PUBLIC UTILITIES COMMISSION

RE: Sycamore- Peñasquitos 230-kV Transmission Line Project— Review of Minor Project Refinement #2 Request

Exhibit 1: Black Mountain Road Re-Route

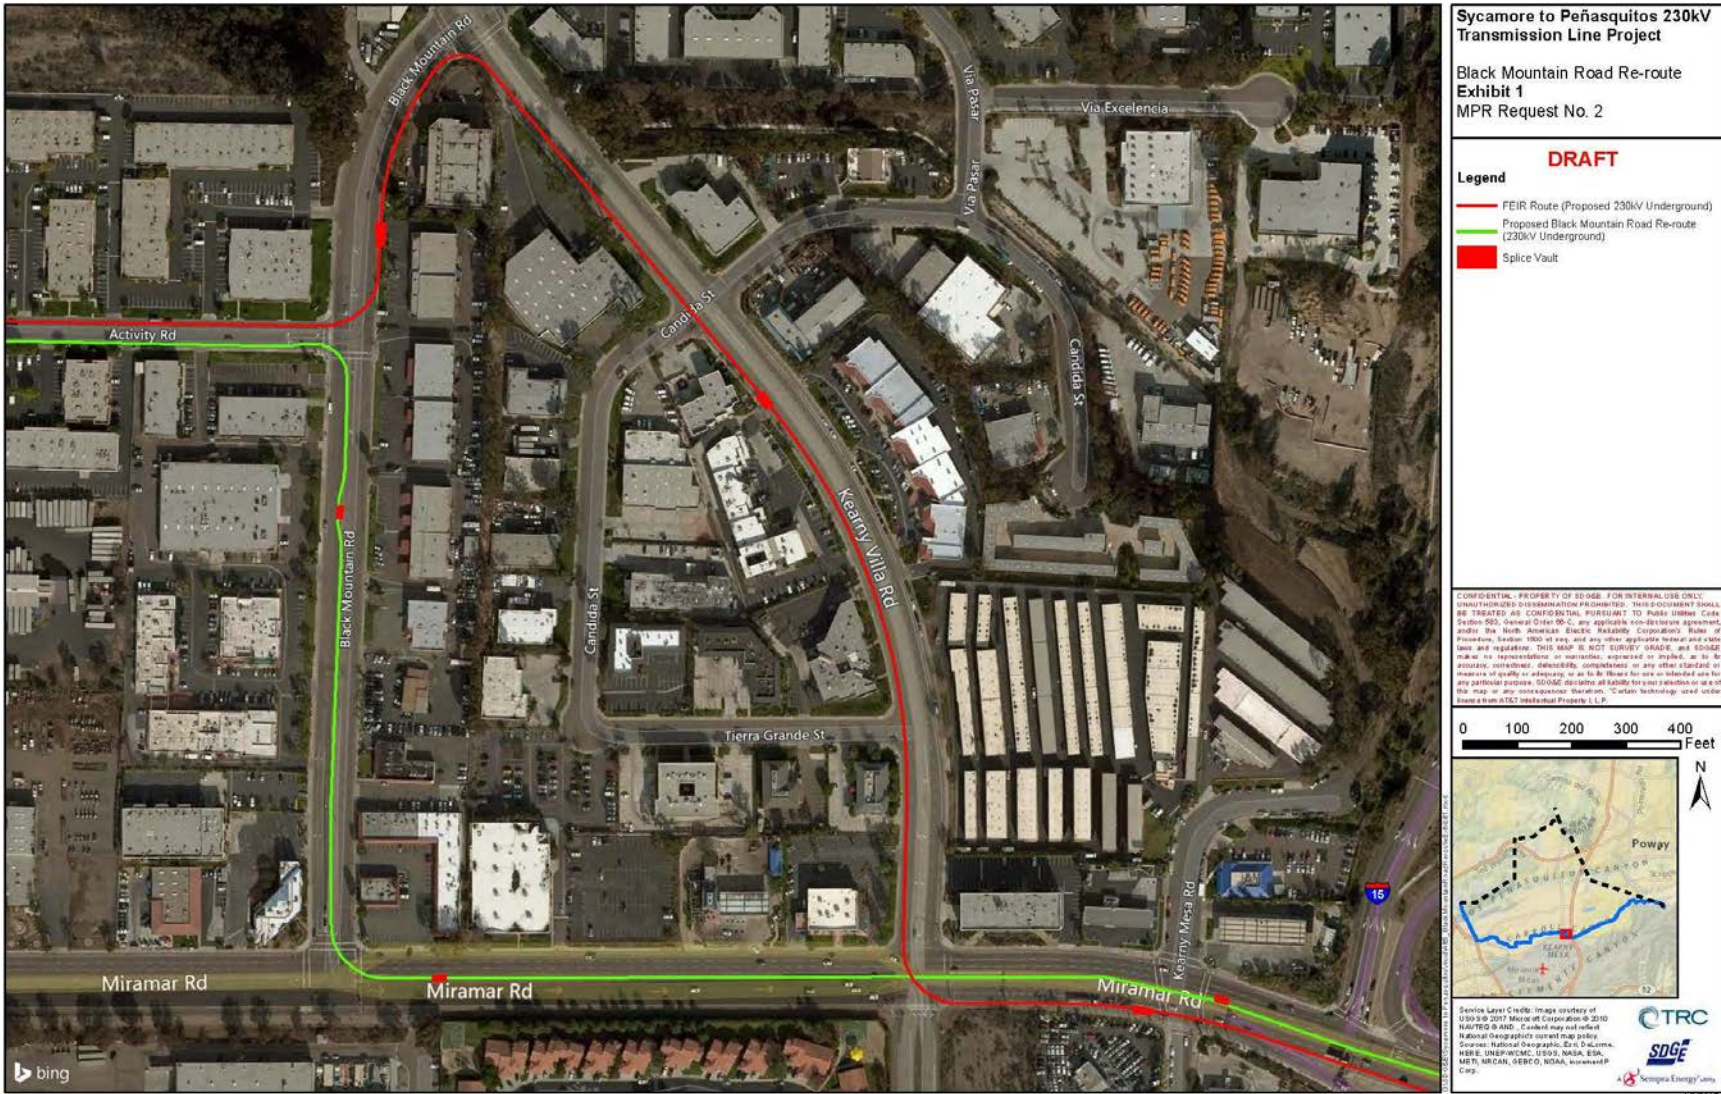
The Final Environmental Impact Report (FEIR) design called for the new 230-kV transmission line to be installed in an underground position following Miramar Road west (across the I-15 Freeway), turning north on Kearny Villa Road, then briefly south on Black Mountain Road, before moving west again on Activity Road (refer to Exhibit 1). The Segment between Miramar Road and Activity Road is approximately 2,600 linear feet.

Under the proposed refinement, the new 230-kV transmission line would continue along Miramar Road (past Kearny Villa Road), before turning north on Black Mountain Road, then ultimately west on Activity Road, consistent with the FEIR route. The 230-kV line with the proposed refinement between Miramar Road and Activity Road would be approximately 2,300 linear feet.

During final design of Alternative 5 (FEIR route or design) and in compliance with Mitigation Measure Utilities-3, SDG&E reviewed the number and location of existing buried utilities along the underground alignment. During that review, SDG&E identified two parallel 192-inch storm drains running diagonally across the intersection of Kearny Villa Road and Black Mountain Road. Exhibit 2 attached shows these two storm drains, which are identified on the drawing as 192" ACCMP SD. The FEIR route at this intersection would require a 110-degree sweep (turn) from Kearny Villa Road to Black Mountain Road. Meanwhile, the cabling system requires a 60-foot minimum radius to maintain allowable cable pulling tensions. This minimum turning radius limits the potential path of the sweep and results in the FEIR route having to cross under the storm drains as it makes the turn. Neither conventional trenching nor tunneling under the storm drains would be possible under this condition. In addition, under the FEIR route, the underground alignment would need to cross these storm drains twice (see Exhibit 2). With implementation of this refinement, the Project would avoid potential conflicts with these two storm drains and the constructability concern described would be eliminated. The refinement also reduces the number of horizontal bends in this section and reduces the linear feet of trench by approximately 300 feet. Less horizontal bends will reduce pulling tensions, which reduces the potential risk of damage to the cable when pulling. The reduced length could also result in an approximately 3-5 day reduction in the overall construction schedule of the underground portion of the Project.

MPR #2 is approved by the CPUC with conditions. The conditions presented below shall be met by SDG&E and its contractors:
